Notice of Intent Application: Additional Information  
**32 Norwood Street**  
**Boston, Massachusetts**  
Ardent file ECLP-1521

Re: Notice of Intent Application: Additional Information  
**32 Norwood Street**  
**Boston, Massachusetts**  
**Ardent** ECLP-1521

Responses to comments from the April 6, 2022 Conservation Commission public hearing

PROPOSED LANDSCAPING PLAN  
 32 NORWOOD STREET  
 DORCHESTER, MA  
 FOR  
 28 NORWOOD STREET LLC  
 CIVIL ENVIRONMENTAL CONSULTANTS

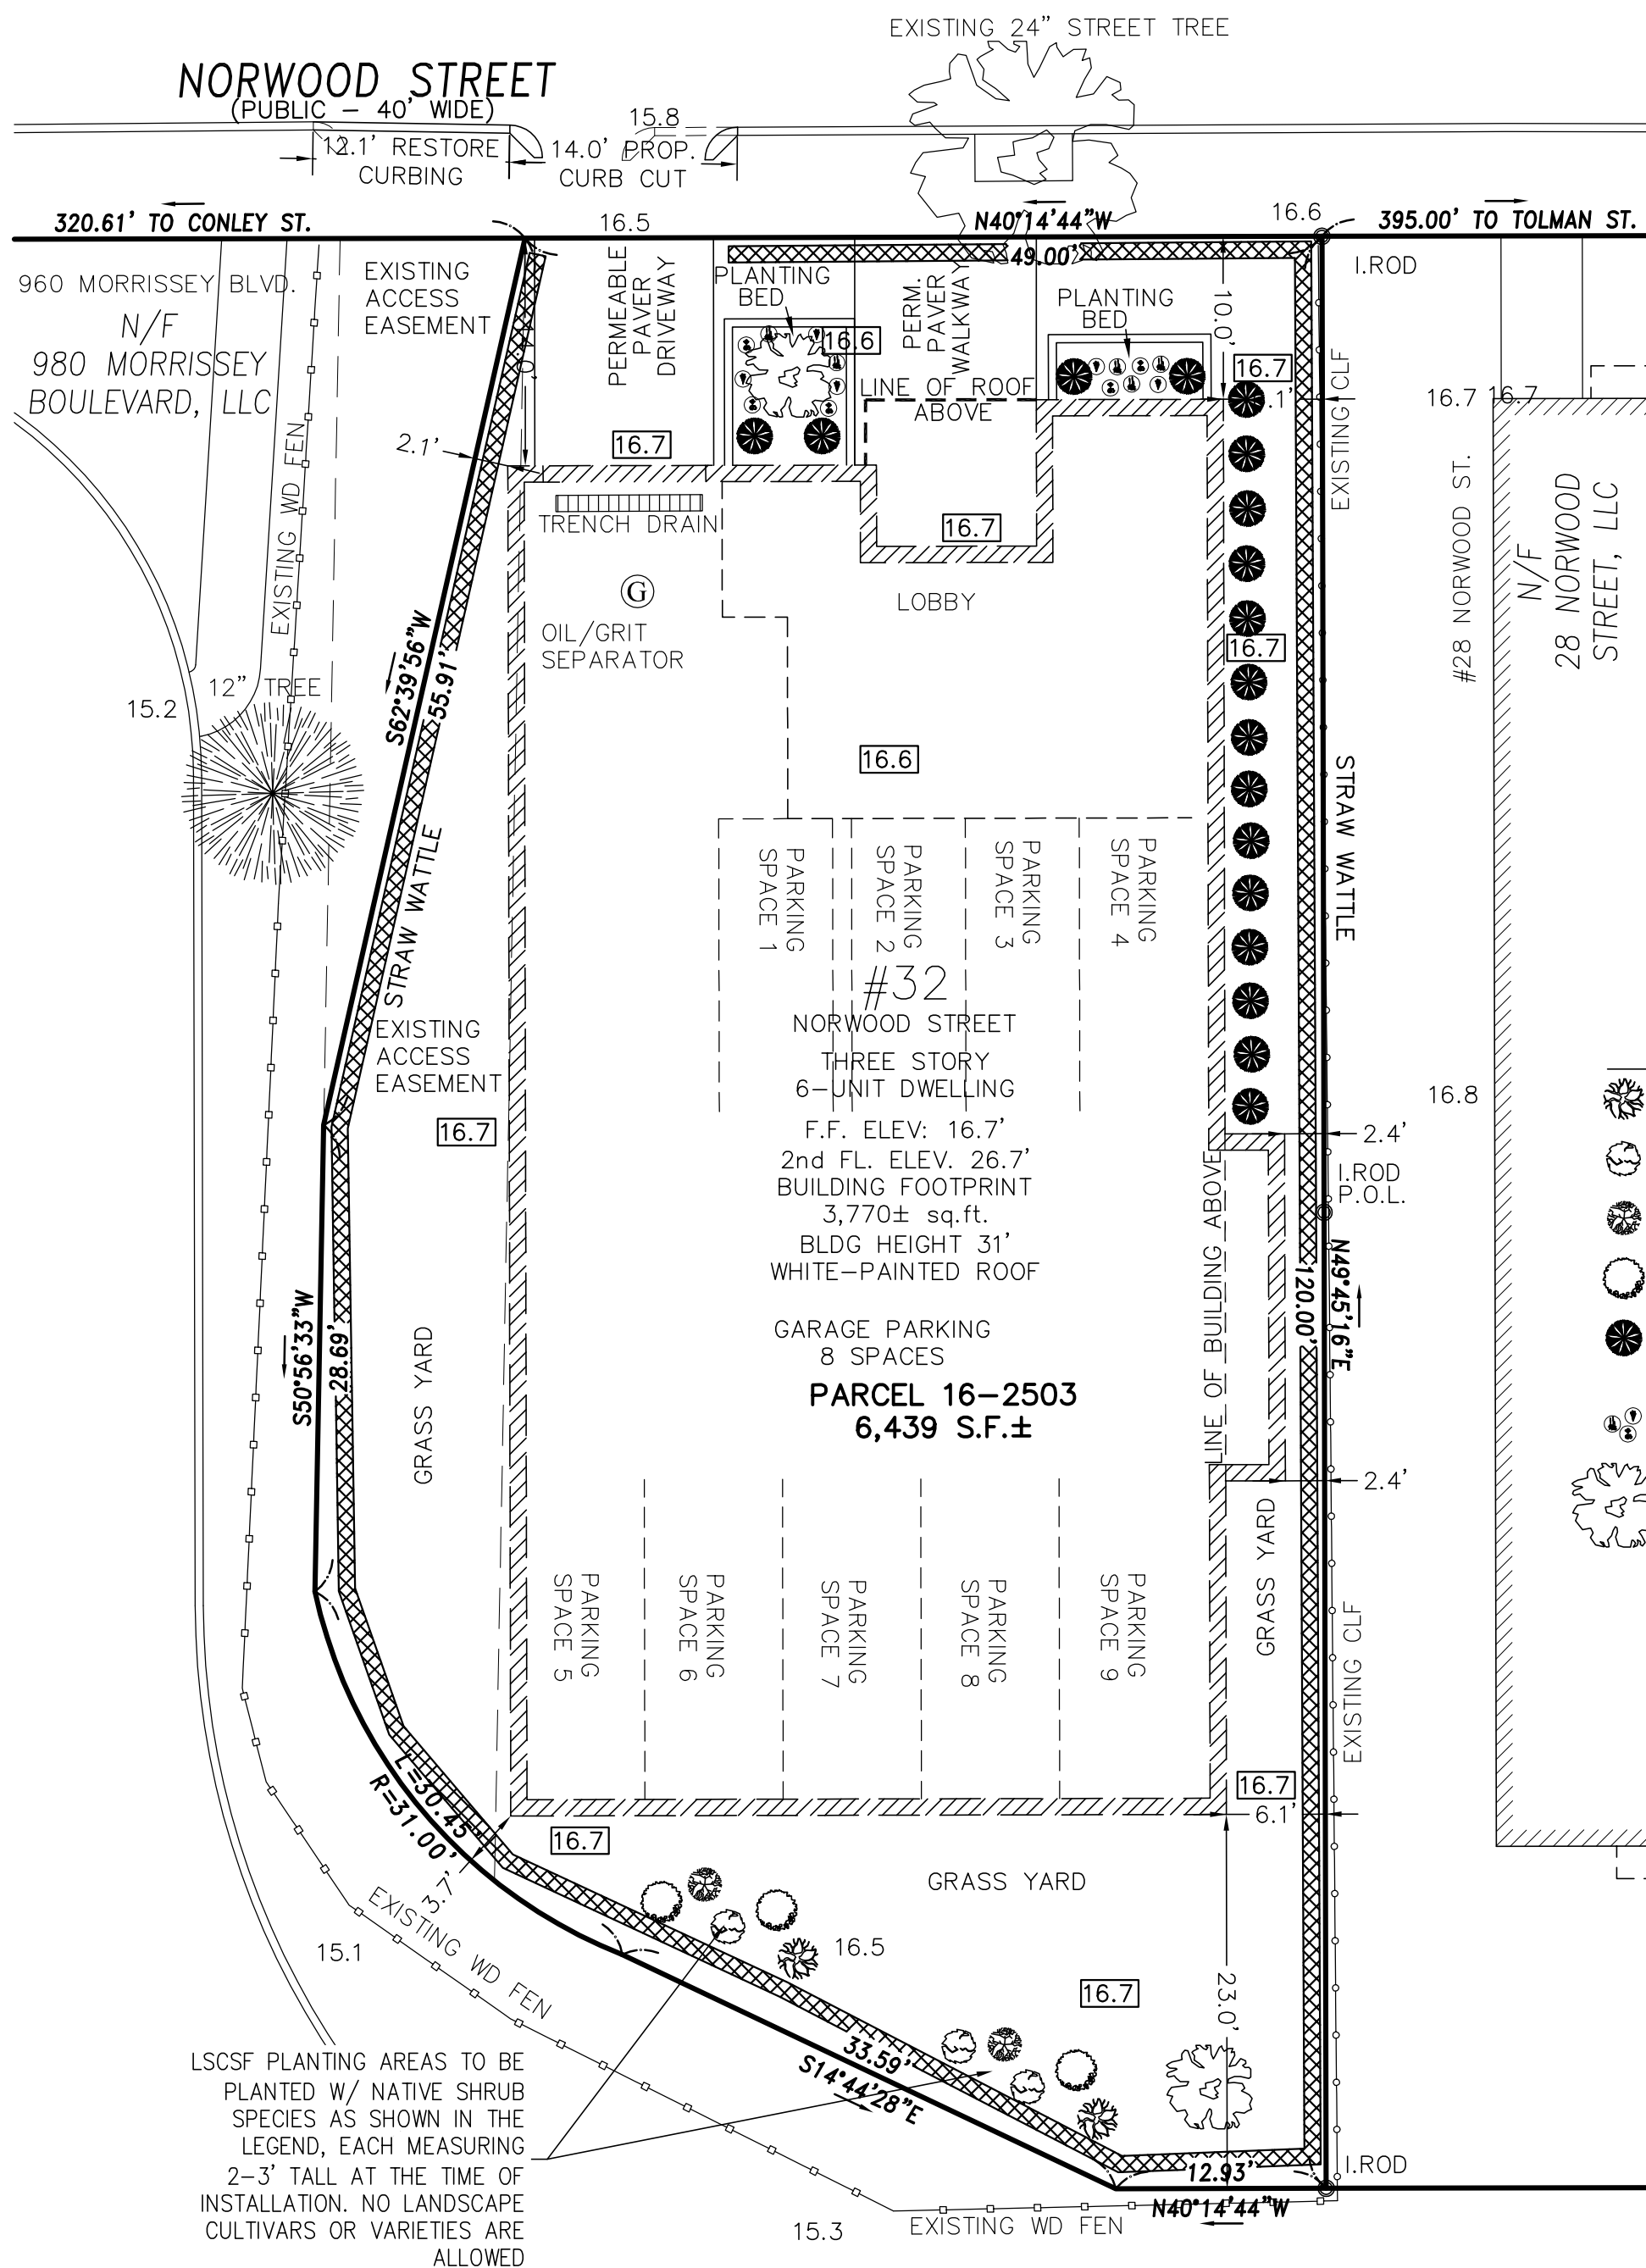
1. A more robust landscaping plan. An updated landscaping plan has been provided that includes additional shrubs, perennials, and grasses, in addition to additional grassed lawn areas. This increases the amount of vegetation at the site per the request.
2. A feasibility analysis if installing a green roof, and if that is not feasible, the use of a white roof coating. The feasibility analysis was completed and it has been determined that the roof cannot support the additional weight that the green roof would require. That signed and stamped letter is attached. Please see the picture of the roof being painted white, which will be completed this week.

**SITE PLAN #21-076**  
 32 NORWOOD STREET  
 DORCHESTER, MA  
 FOR  
 PERRY BRUNO

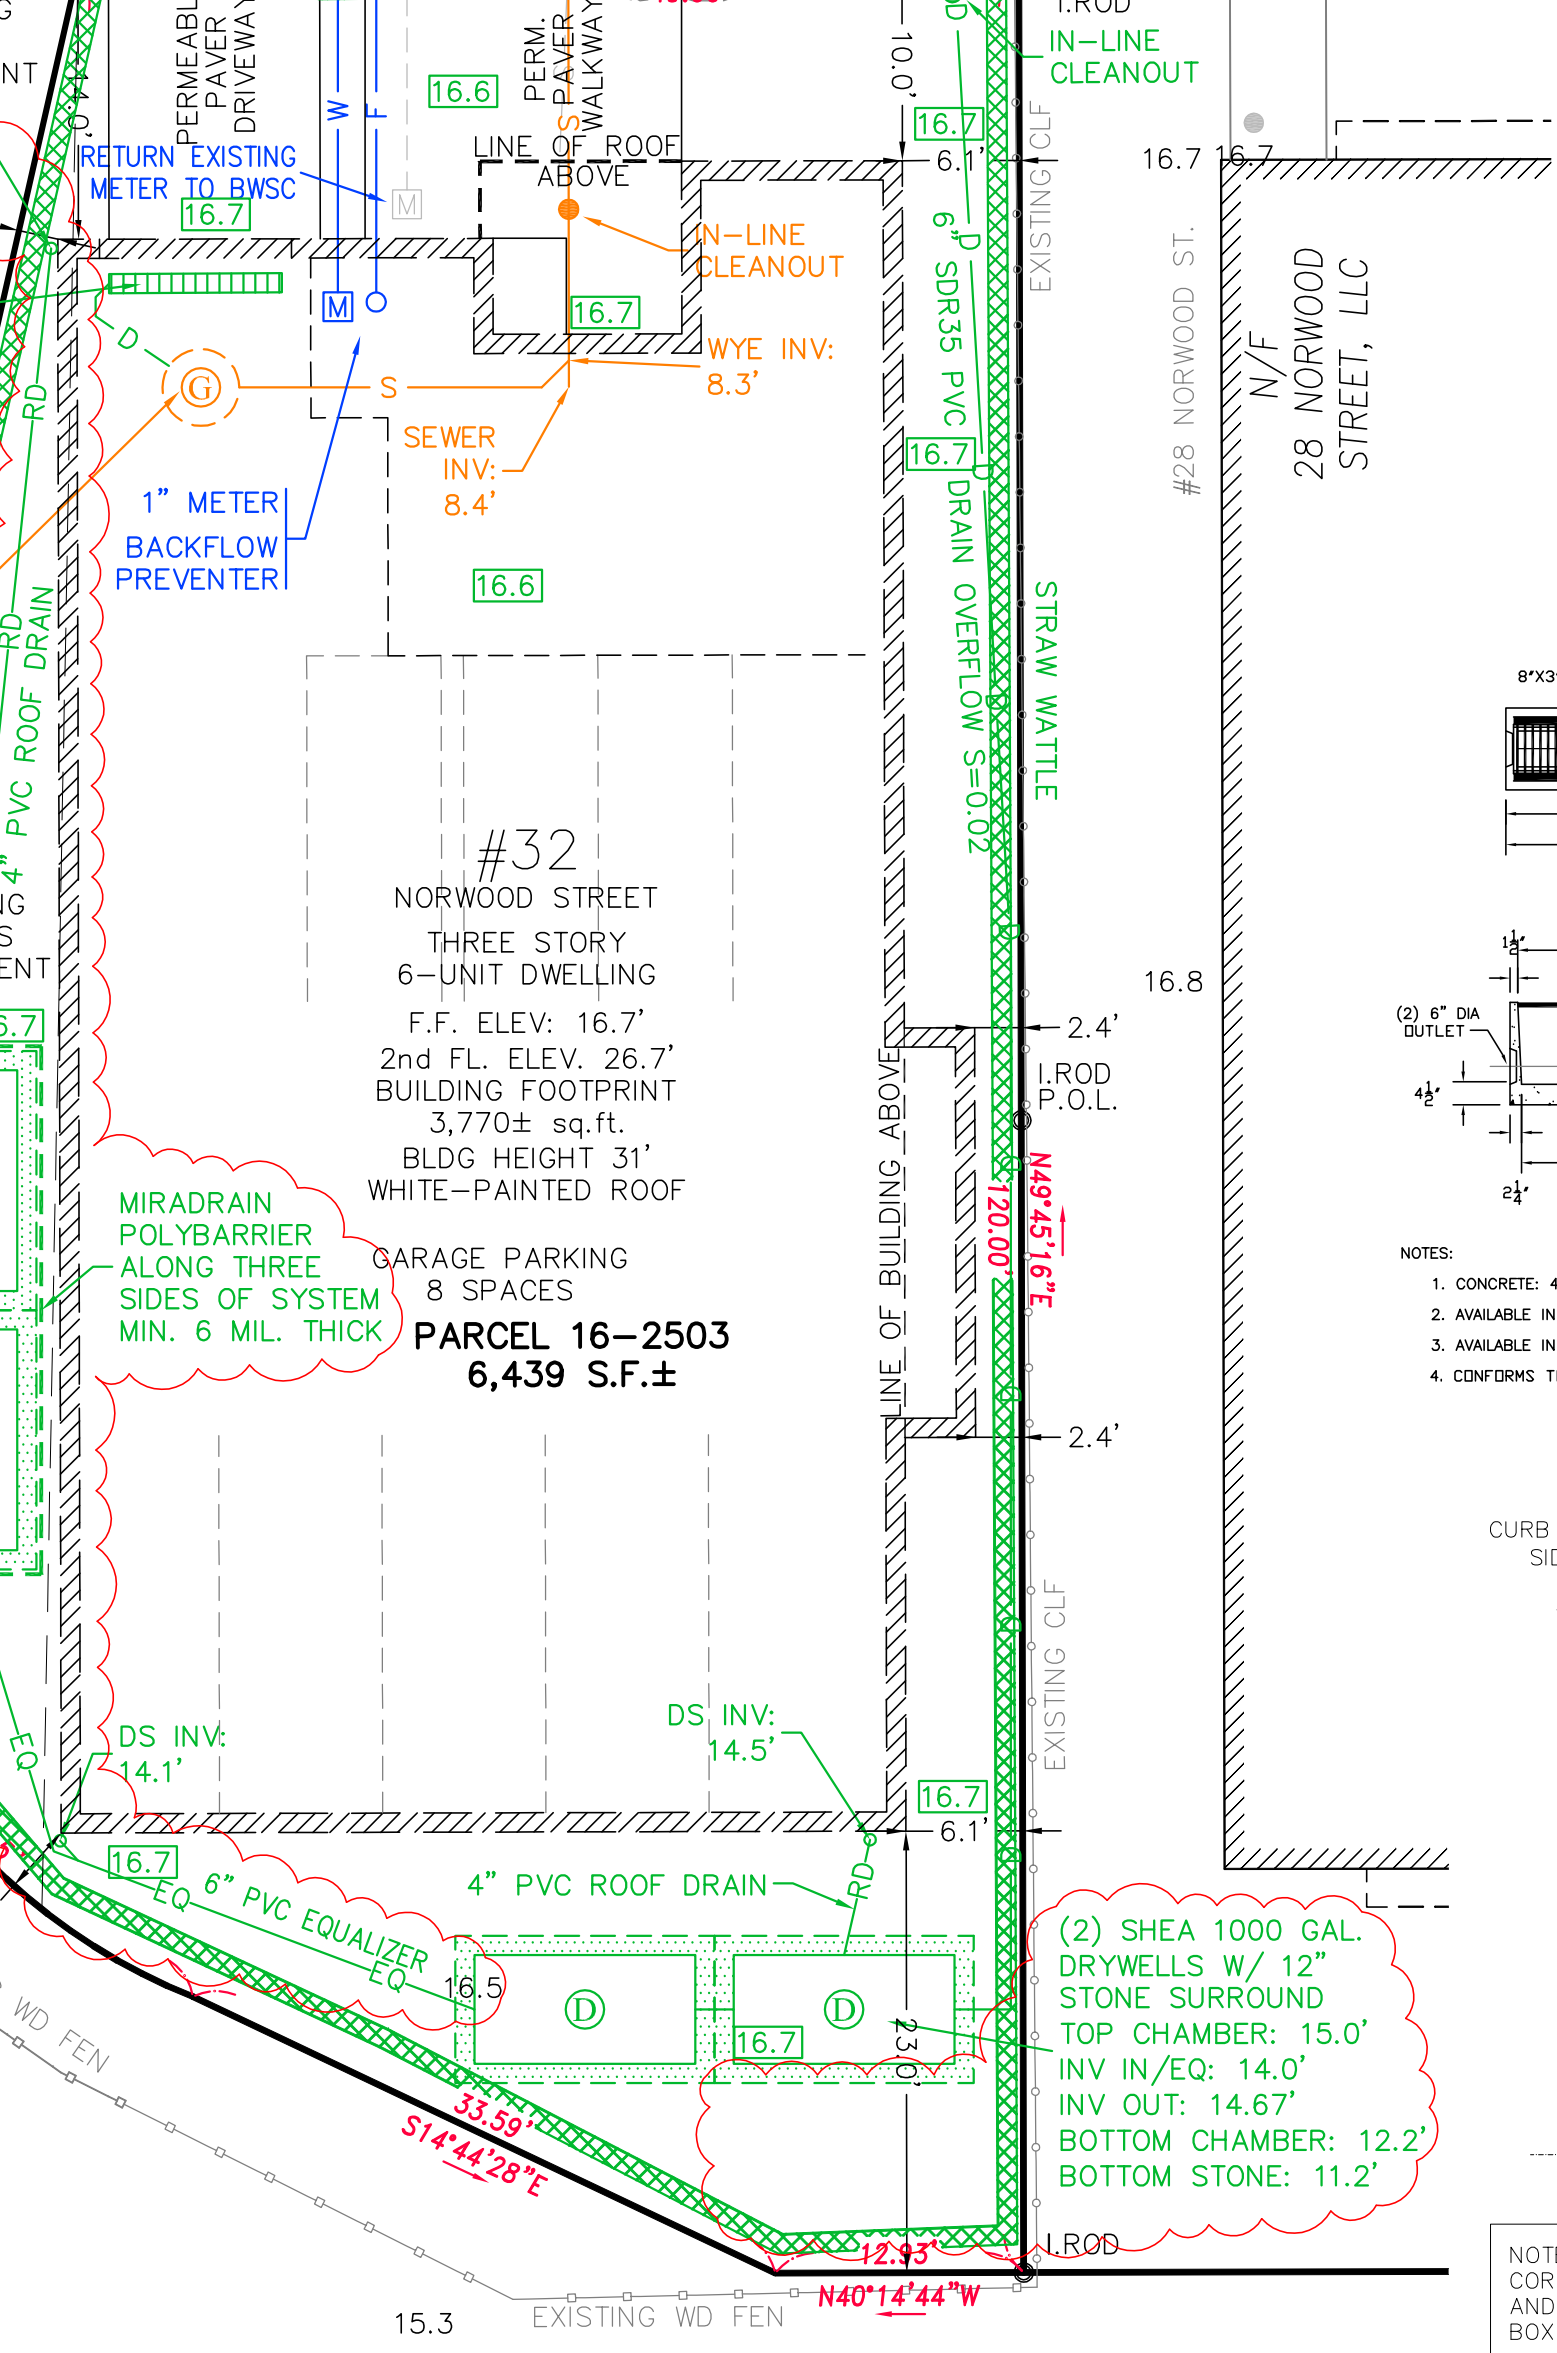
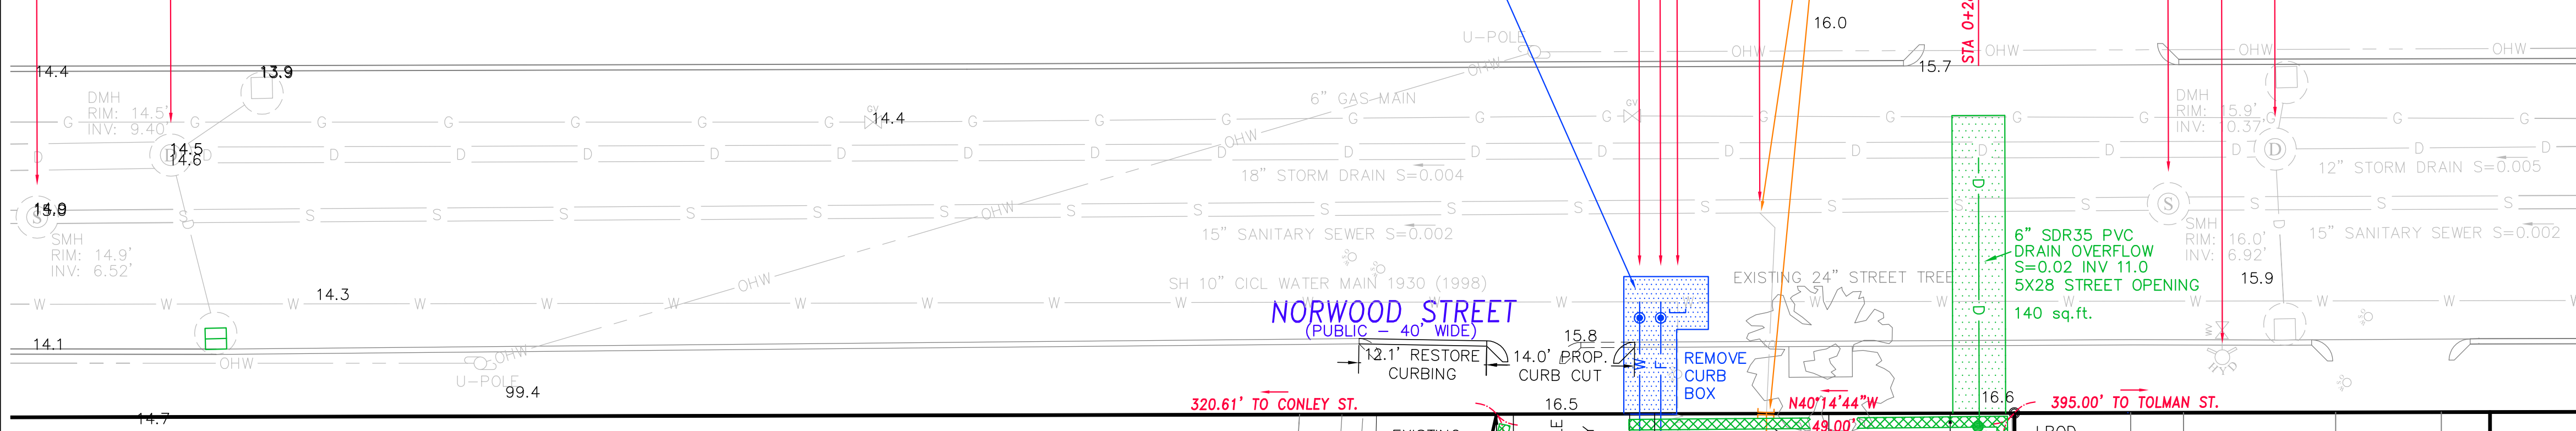
3. An increased amount of stormwater to be retained onsite. Please see the attached plan that shows the addition of another 1,000-gallon dry well on the western side of the building. This plan will be submitted for BWSC signature. Previously we had included three 1,000-gallon dry wells and received BWSC sign off. The overflow will remain, but the additional water storage capacity means that this should not be needed.

**32 NORWOOD STREET GROUNDWATER RECHARGE CALCULATIONS**  
 IMPERVIOUS AREA: 3860.9 sq.ft.  
 INFILTRATE 1" OF RAINFALL  
 $3860.9/12 = 321.7$  CU.FT. RECHARGE CALCULATION  
 (4) 1000 GALLON DRYWELL INFILTRATION SYSTEM  
 VOLUME OF CHAMBER 514.4 CU.FT.  
 VOLUME OF STONE CALCULATION  
 $13.5' \times 7.67' \times 3.5' = 362.4$  CU. FT. STONE VOLUME PER CHAMBER  
 $362.4 \times 4$  CHAMBERS = 1449.6 CU. FT. TOTAL STONE VOLUME  
 $1449.6$  CU. FT. STONE - 514.4 CU. FT. CHAMBER VOLUME  
 $= 935.2$  CU. FT. VOLUME STONE x 0.3 (VOIDS) = 280.6 CU.FT. TOTAL VOID STORAGE  
 $280.6$  VOID STORAGE + 514.4 CHAMBER STORAGE = 795.0 CU. FT. TOTAL STORAGE  
 $795.0$  CU. FT. SYSTEM STORAGE > 321.7 CU. FT. REQUIRED STORAGE VOLUME  
 SYSTEM IS OVERSIZED TO MEET MA DEP REGULATIONS FOR A 10-YR STORM EVENT

INCREASED & ADJUSTED INFILTRATION SIZE PER CONCOM REQUEST	C.R.L.	4/13/2022
REVISE INFILTRATION DUE TO CONCOM REQUIREMENTS	L.J.B.	1/27/2022
MIRRORED BLDG. PER BPDA REQUEST, ADJUSTED WTR. SVC. LOC'NS	C.R.L.	3/19/2021
